National Committee on Uniform Traffic Control Devices

TECHNICAL COMMITTEE: Guide and Motorist Information (GMI)

TOPIC: Weigh (Inspection) Stations

SUMMARY:

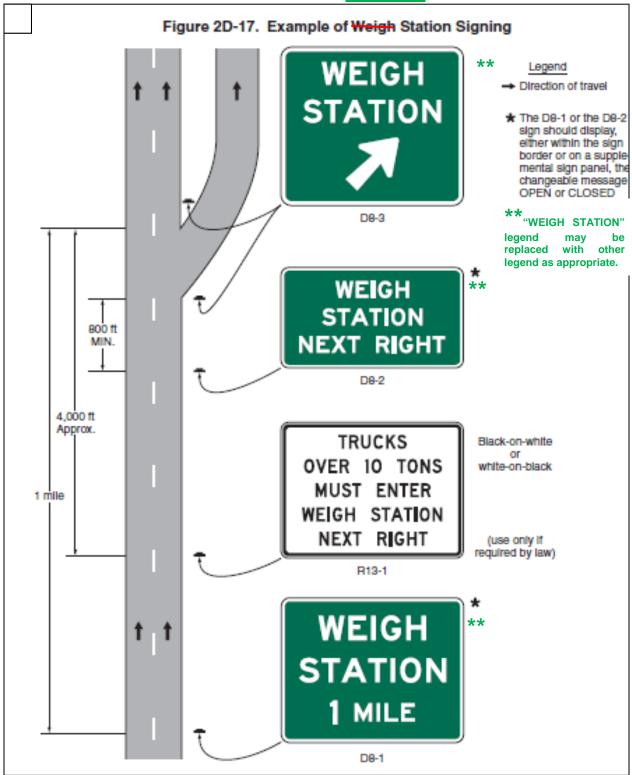
The R13-1 legend may be modified to match the specific type of inspection conducted at the station.

- Example locations of these signs are shown in Figure 2D-17. 03
- 39 Option:
 - Where State law requires a regulatory sign (R13-1) in advance of the Weigh Inspection Station, a fourth sign (see Section 2B.60) may be located following the Advance sign.
 - Where the Inspection Station conducts only one specific type of inspection, such as weight or agriculture; the D8 sign series Inspection Station legend may include "WEIGH", "AGRICULTURE" or other appropriate legend to match the specific type of inspection conducted at the station.
